To: Plan Holders for SLN Terminal Expansion  
Salina Regional Airport  
Salina, KS  
AIP Project Number 2-20-0072-054/055-2024

Transmitted herewith Addendum No.2 to the Issued for Bid Contract Documents, Specifications and Plans dated July 2, 2024 for improvements to the Salina Regional Airport.

**ADDENDUM NO. 3**  
**TO**  
**CONTRACT DOCUMENTS, TECHNICAL SPECIFICATIONS, AND**  
**PLANS**  
**FOR IMPROVEMENTS TO THE**  
**SALINA REGIONAL AIRPORT**  
**SALINA, KS**  
**AIP PROJECT NUMBER 2-20-0072-054/055-2024**

SHEET NO:  
**S2.10**

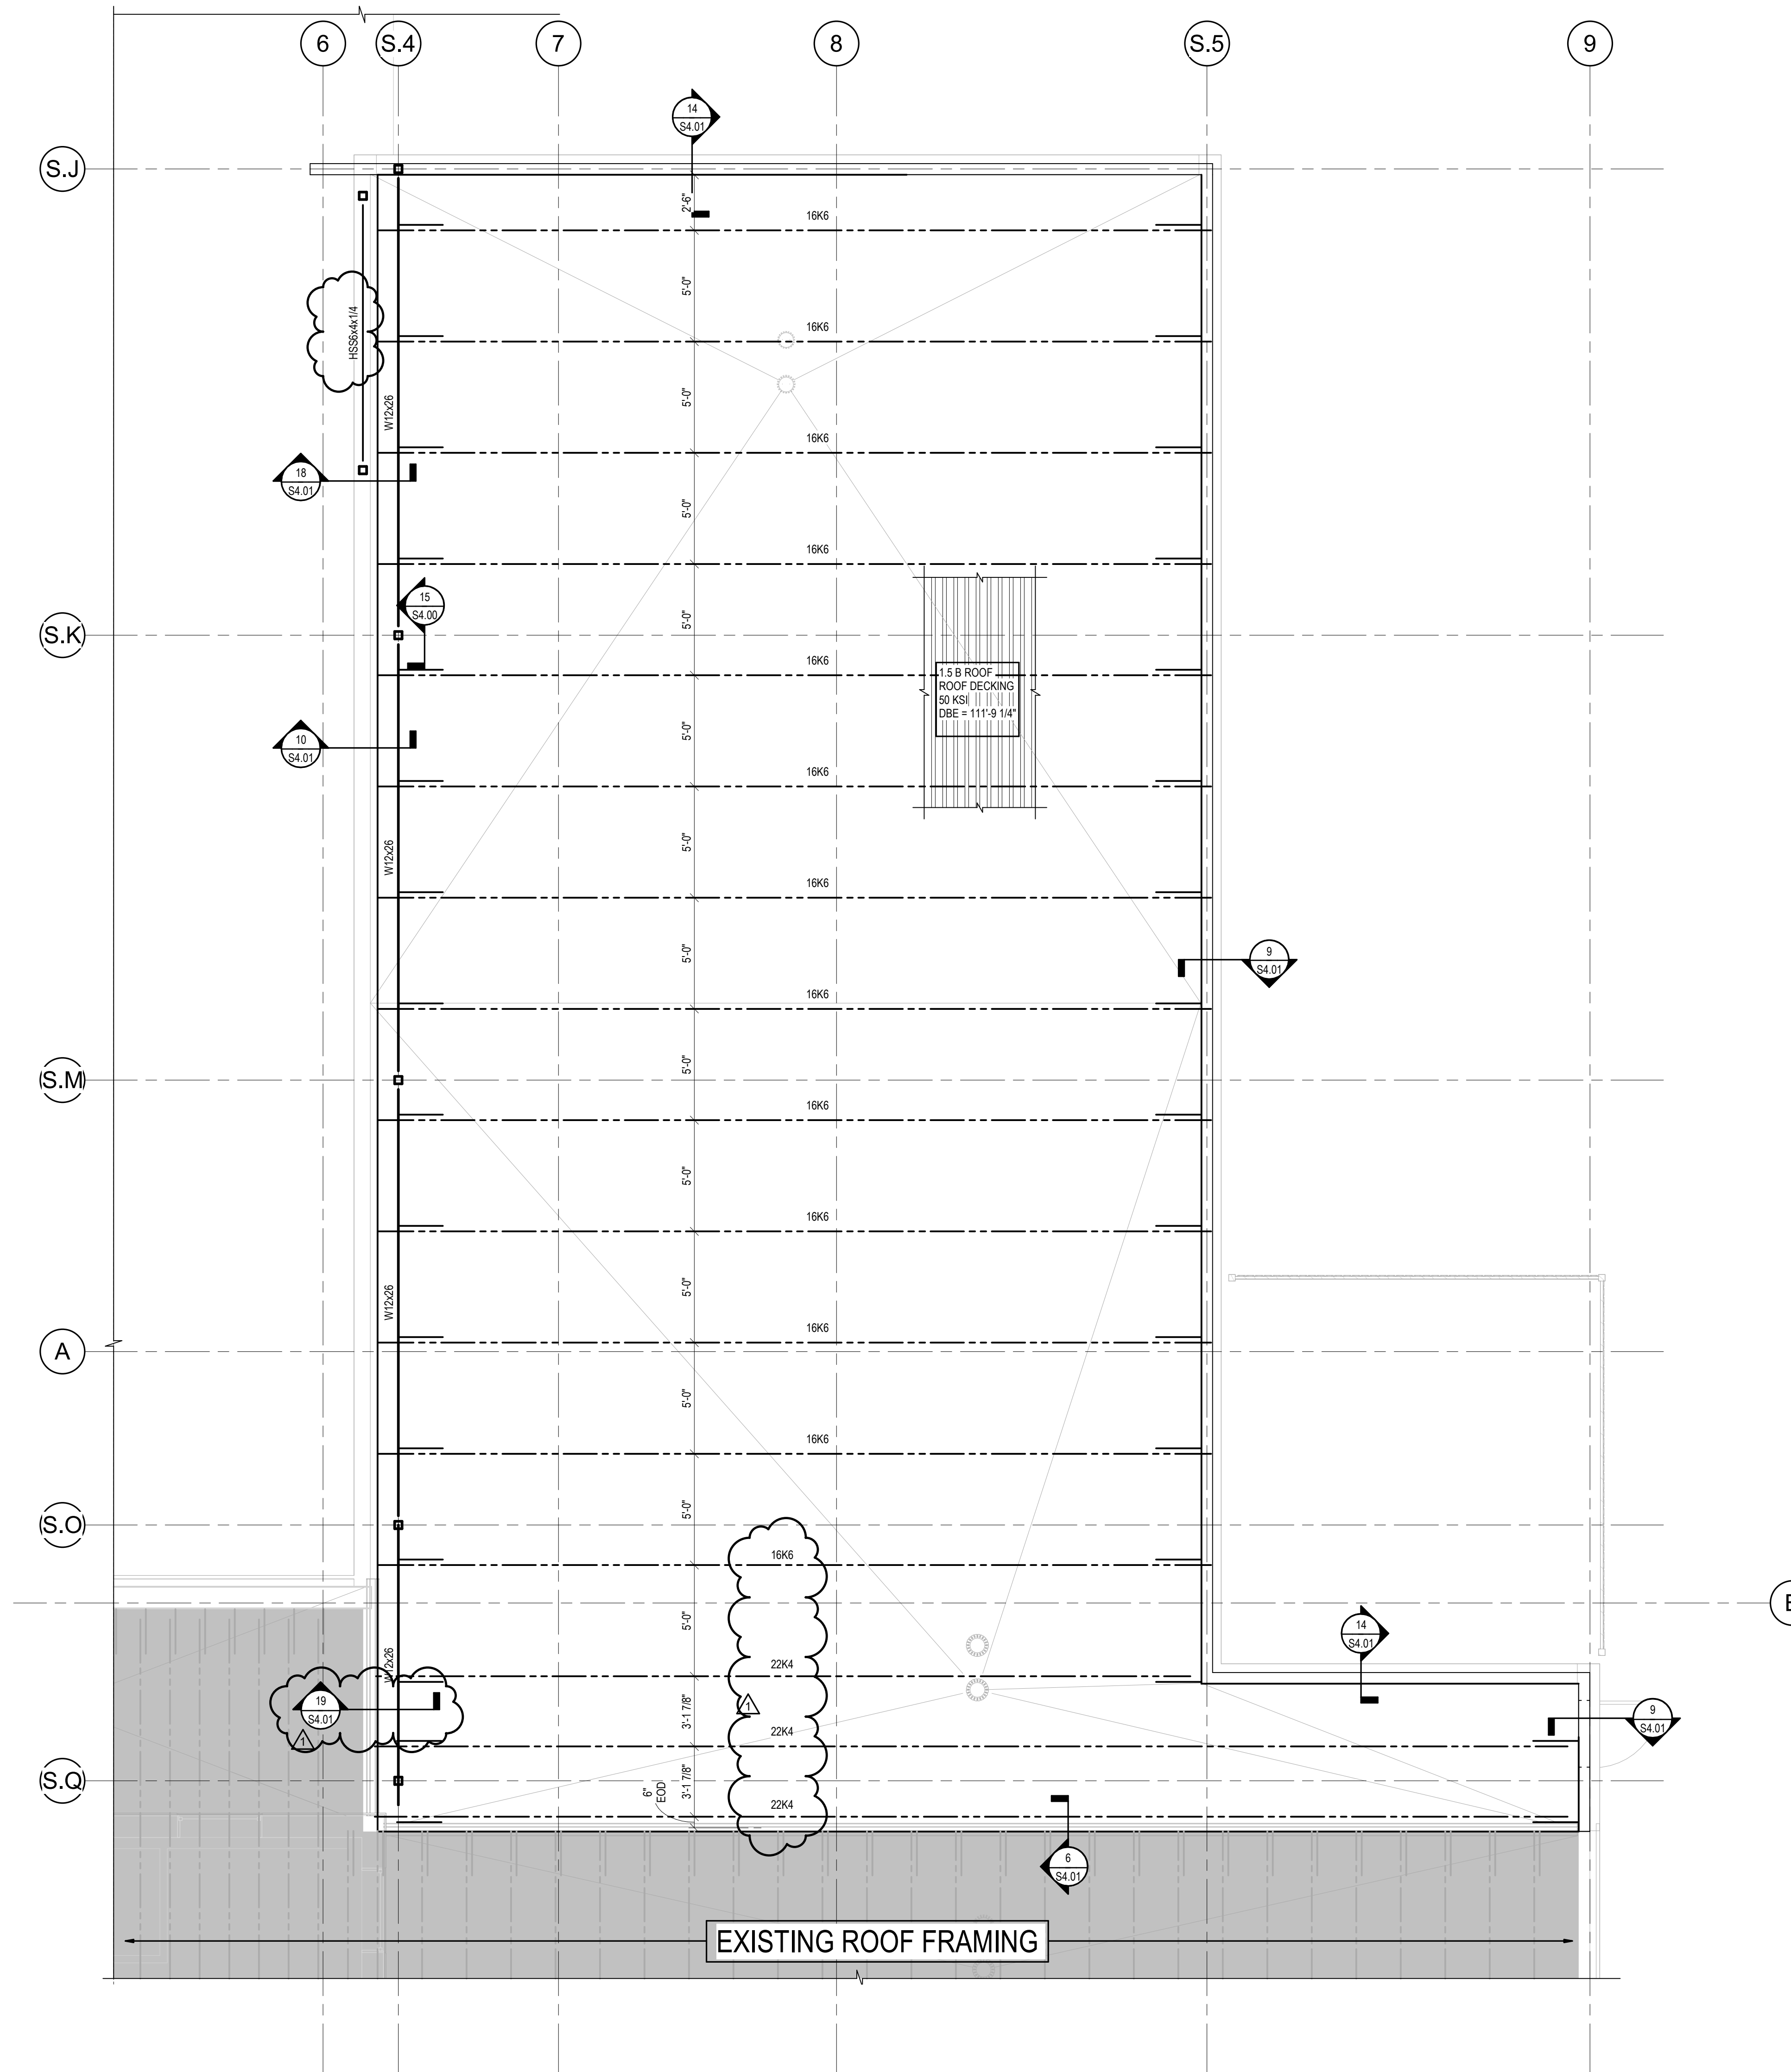
**S210 BAGGAGE ROOF FRAMING PLAN**

**Justification:** For clarification.

SHEET NO:  
**S2.11**

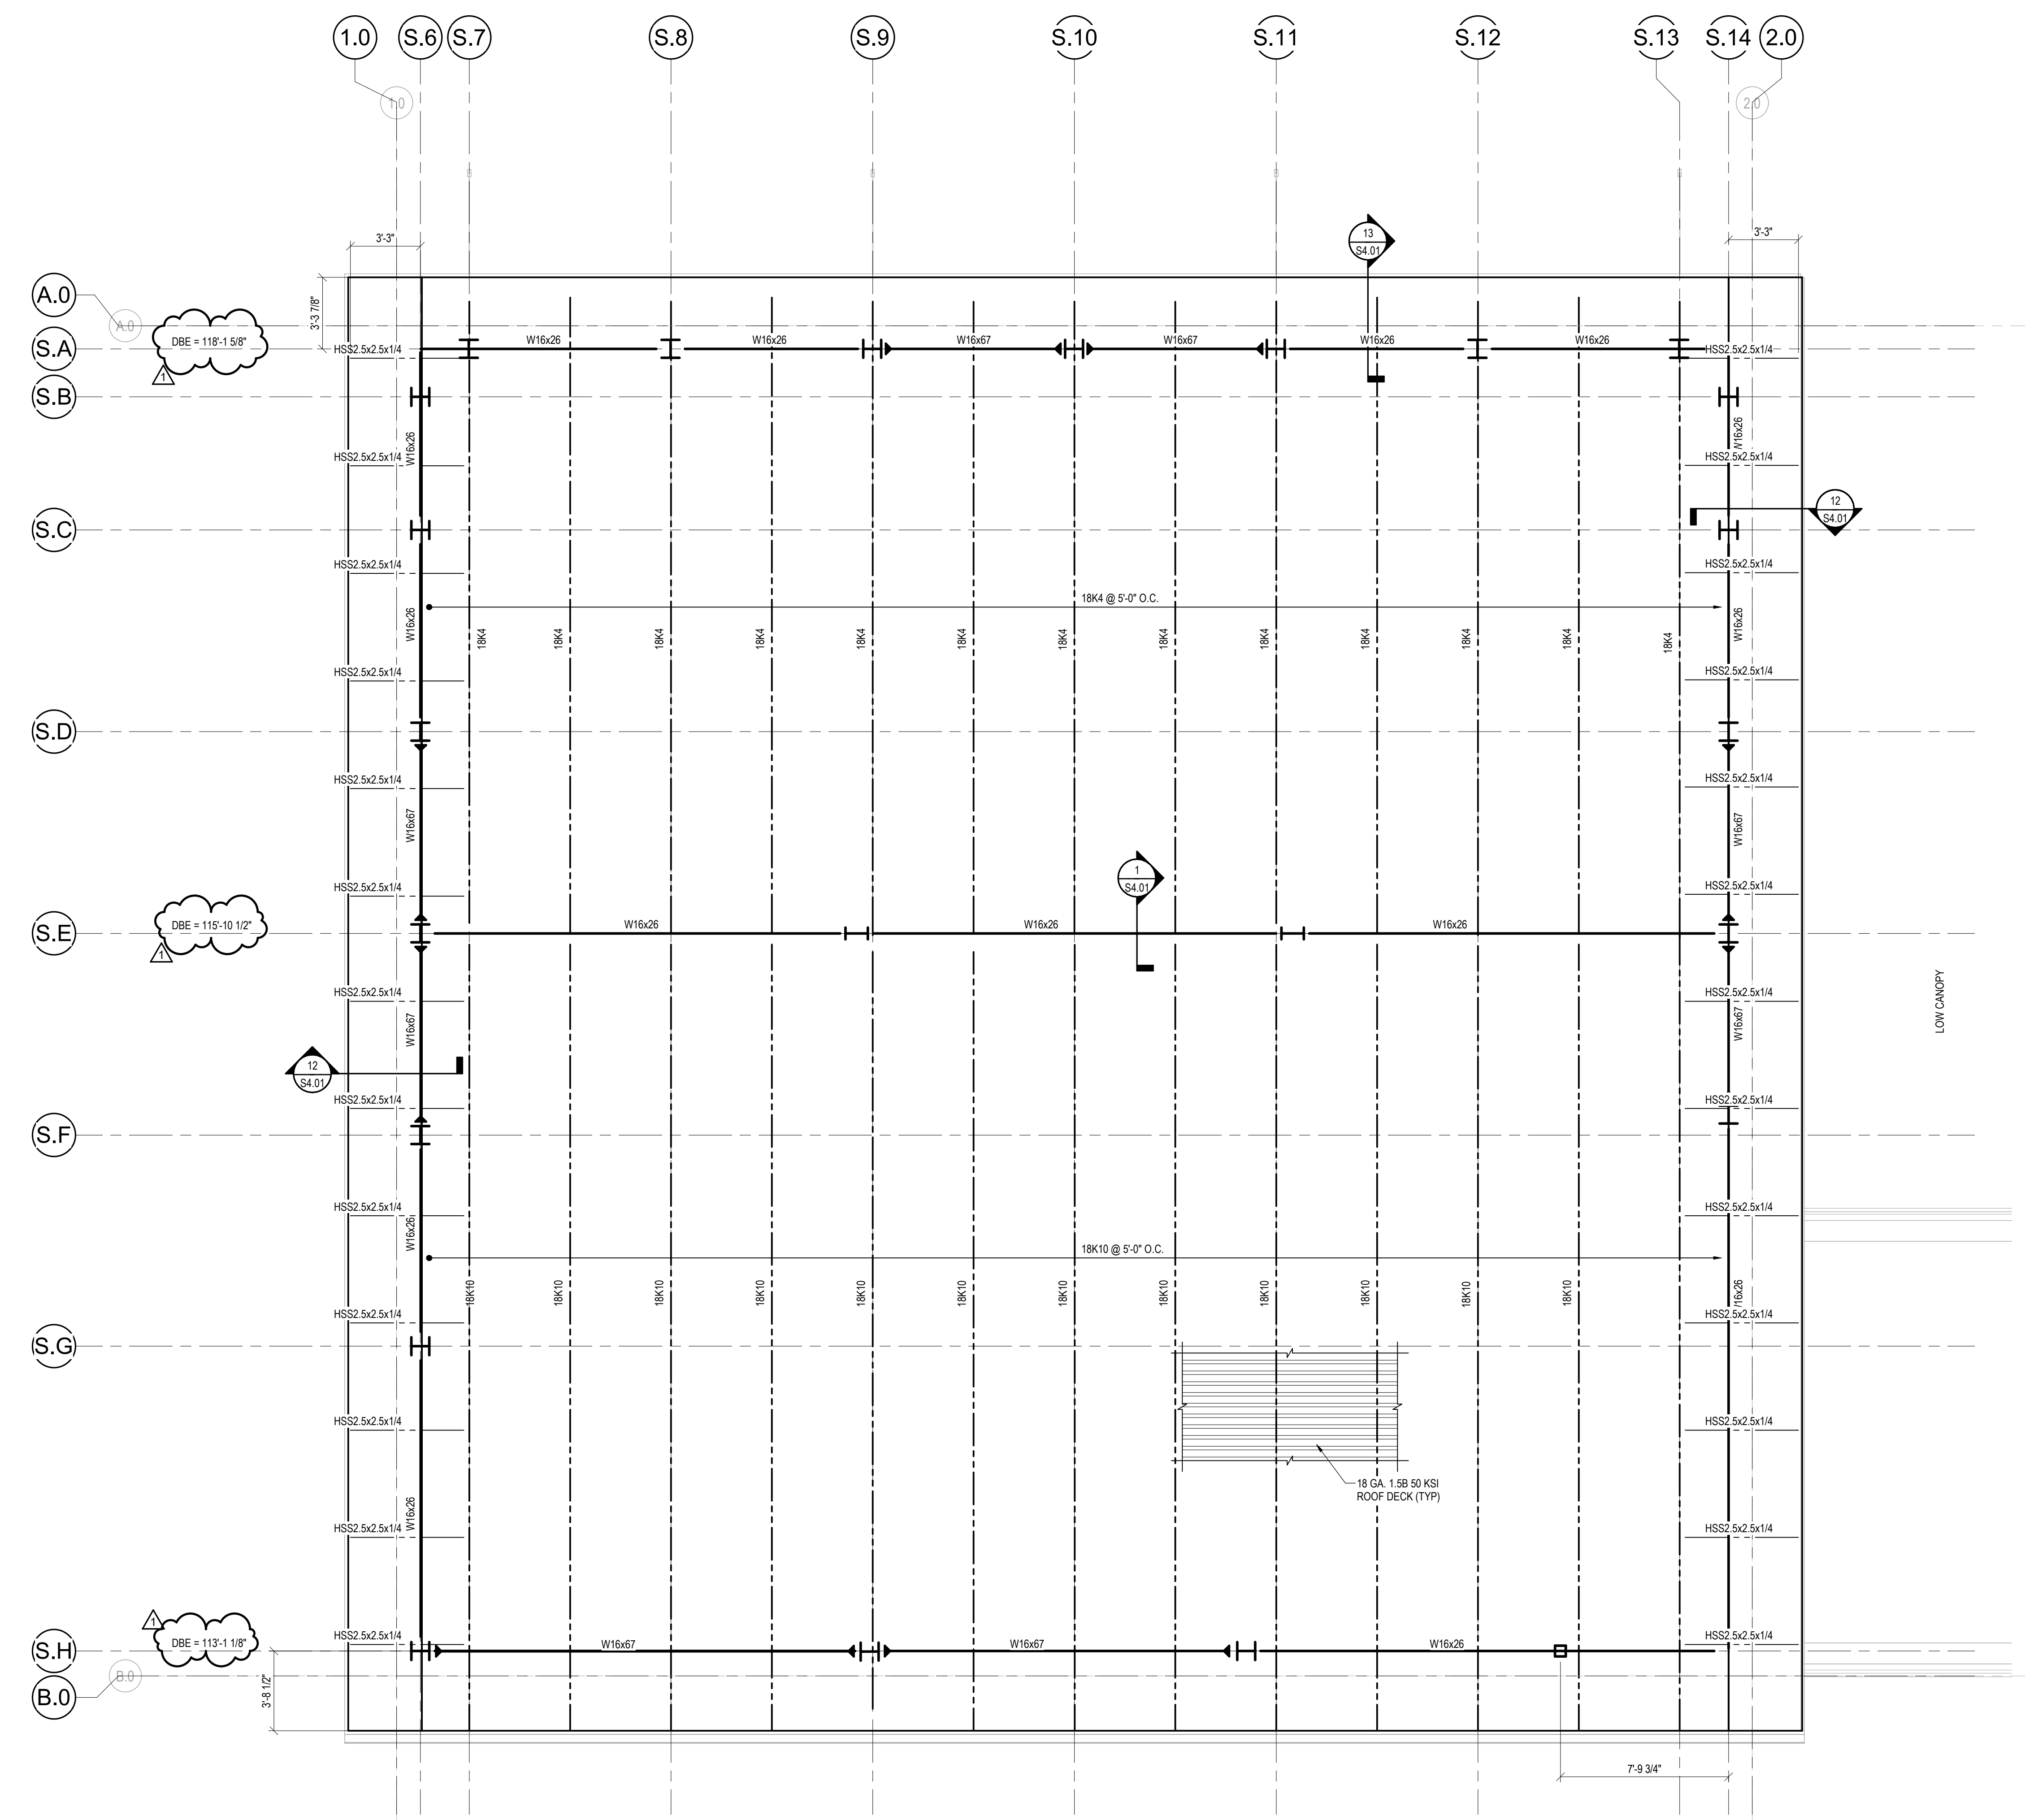
**S211 CHECKPOINT ROOF FRAMING PLAN**

**Justification:** For clarification.
